UNITED STATES PATENT AND TRADEMARK OFFICE

APPLICATION NO.	FILING DATE	FIRST NAMED INVENTOR	ATTORNEY DOCKET NO.	CONFIRMATION NO.
10/589,609	08/16/2006	Jorg Knyrim	A-10135	2670
20741 7590 09/18/2008 HOFFMAN WASSON & GITLER, P.C. CRYSTAL CENTER 2, SUITE 522 2461 SOUTH CLARK STREET ARLINGTON, VA 22202-3843				
EXAMINER				
GILBERT, SAMUEL G				
ART UNIT		PAPER NUMBER		
3735				
MAIL DATE		DELIVERY MODE		
09/18/2008		PAPER

Office Action Summary

DETAILED ACTION

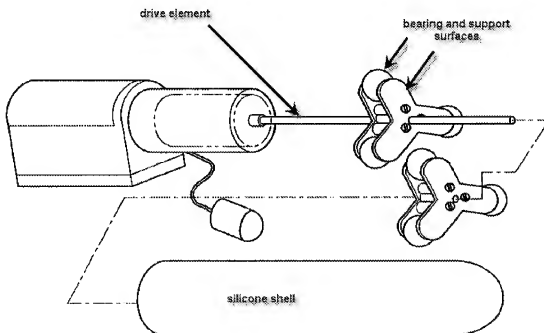
Claims 1-3 and 11 are rejected under 35 U.S.C. 102(e) as being anticipated by Chen (6,632,185).

Claim 1 - a shell, drive element, bearing and support surfaces are set forth in Figure 2. The shell is made of silicone which is a rubber-elastic material. The oscillation is in the peripheral direction as the bearing surfaces rotate about the drive element. The examiner is taking the claim to only require oscillation in one direction because of the "and/or" language. The language "preferably phase-delayed" is not required, only preferable.

Claim 2 - the device includes a plurality of bearing and support surfaces driven by the drive element.

Claim 3 - the examiner is considering the three armed support surfaces as jaws for holding the bearing surfaces.

Claim 11 - the drive element is a single shaft.
